Virtual information meeting on the REM in Laval – Highlights and answers to the remaining questions

Date and time: January 27, 2021, 6:30 to 8:30 p.m.

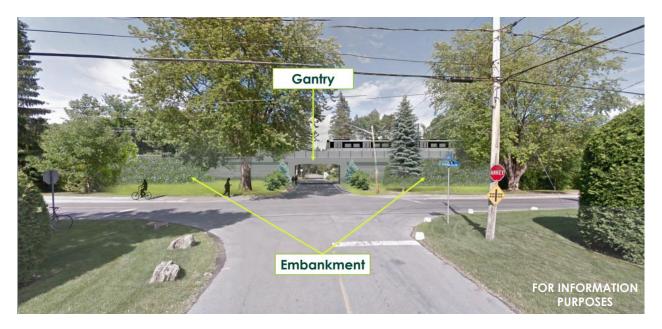
Will the REM be on the ground or elevated in Laval-sur-le-Lac? What will be the height of the track on Les Peupliers Street? We are concerned about the impact of an elevated structure on the landscape.

- The track will be elevated in two locations to eliminate level crossings: over Les Cèdres Street and over Les Érables Street. In both cases, the elevation of the track will be gradual, in order to respect the maximum embankments (see the map below, also available in the presentation).
- Maximum height above Les Cèdres Street: approximately 5.5 metres (including a 4.5-metre clearance under the structure).
- Most of the raised structure will be covered by a sloping vegetated embankment to mitigate its presence in the environment.
